Officer Assessment Report

PA2504013 – 95-97 Melon Street, Braybrook

Key Information	Details												
Application No:	PA2504013												
Received:	21 October 2025												
Applicant:	Homes Victoria												
Planning Scheme:	Maribyrnong												
Land Address:	95 & 97 Melon Street, Braybrook (Lots 21 and 22 of Plan of Subdivision LP059127)												
Development Value:	\$8 million												
Why is the Minister responsible?	In accordance with Clause 72.01-1 of the Planning Scheme, the Minister for Planning is the responsible Authority for this application because the Minister for Planning is the responsible authority for matters under Divisions 1, 1A, 2 and 3 of Part 4 of the Act, and endorsement of, approval of or being satisfied with matters required by a permit or the scheme to be endorsed, approved or done to the satisfaction of the responsible authority, in relation to the use and development of land for a development to which clause 53.23 applies.												
Why is a permit required?

Figure 5 - Typical east-west section showing the compliance of the building from the rear (western) boundary

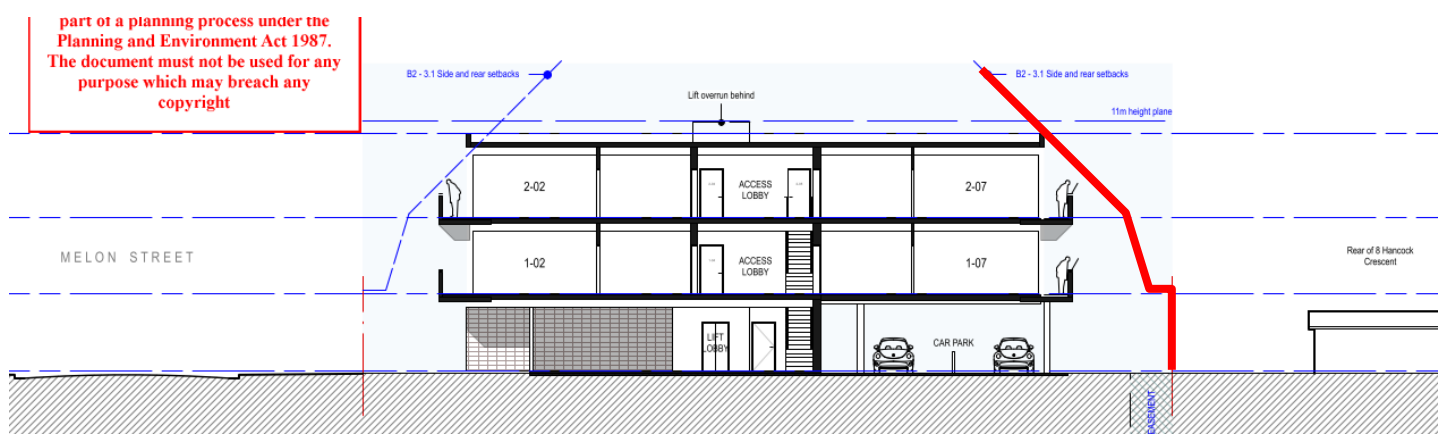
43. The building is setback 4.5m from the western (rear) boundary. This complies with the requirements of clause 55.02-3 (side and rear setback), given that it meets the requirements specified under standard B2-3.1.

Figure 6 – Extract of the streetscape (East) elevation showing the extent of non-compliance with standard B2.3-1.

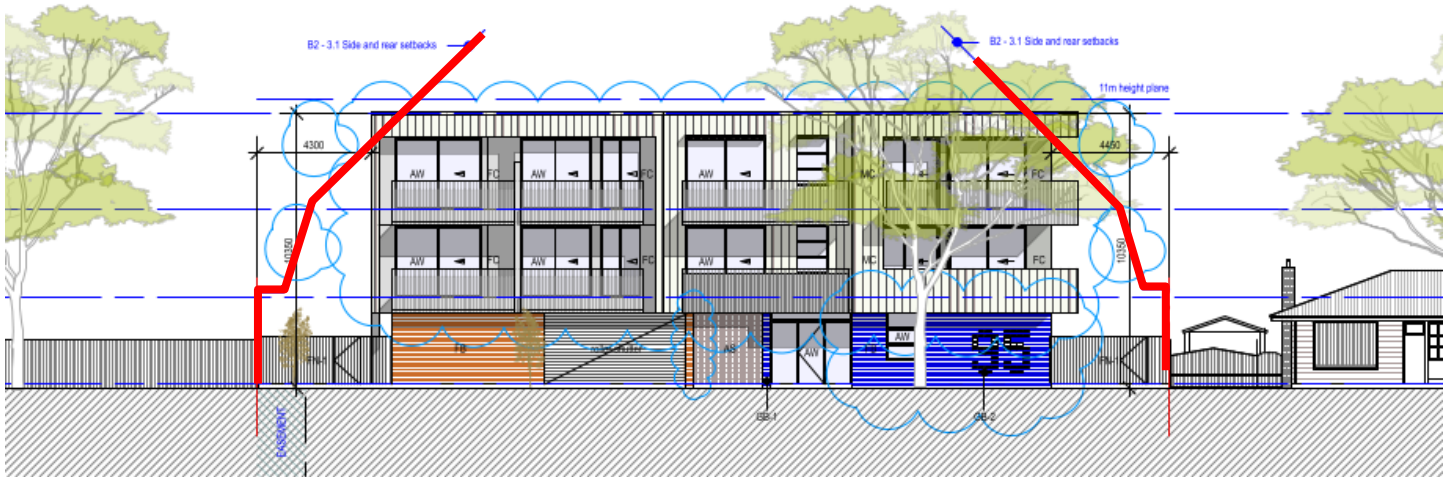
44. The proposal is not fully setback in accordance with the requirements of standard B2.3.1. A variation is supported for the following reasons:
- Where adjacent to 99 Melon Street (north), it is next to the driveway is not considered a sensitive interface. As such, a minor incursion is supported.
 - Where adjacent to 93 Melon Street (south), it is a vacant land. As such, there is no unreasonable visual impact caused this property
 - It is also noted that the non-compliance is due to canopy feature of the built façade encroaching into the setbacks, rather than a deliberate attempt to maximise yield, as generally shown in Figure 6.
45. As such, the objective is met.

Figure 7 - Extract from the landscape concept plan showing the proposed landscape features

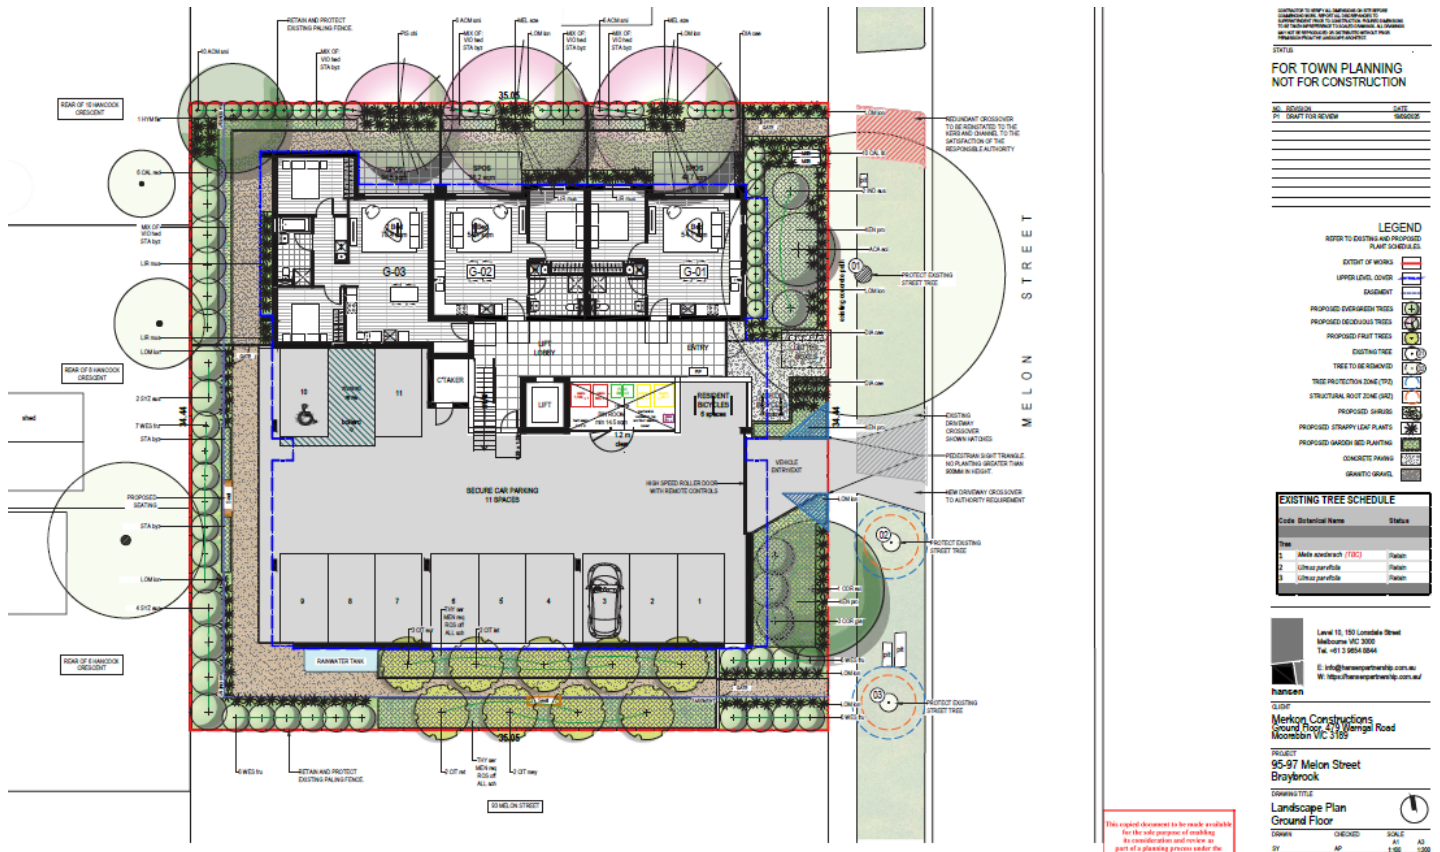
56. The application was accompanied by a landscape concept plan. The plan illustrates that:
- The frontage will provide a combination of new canopy trees, grass and low level shrubs, replacing the removed low value vegetation currently on site. These elements are considered appropriate and conducive towards creating a ‘front garden’ character that prevails within this part of Braybrook.

- The proposal provides a combination of small and medium canopy trees throughout the development such that it meets the objective of clause 55.02-7 (standard B2-7 – trees canopy)
- The proposal avoids unreasonable impacts to the existing street trees. A tree protection management plan will be required via permit condition.
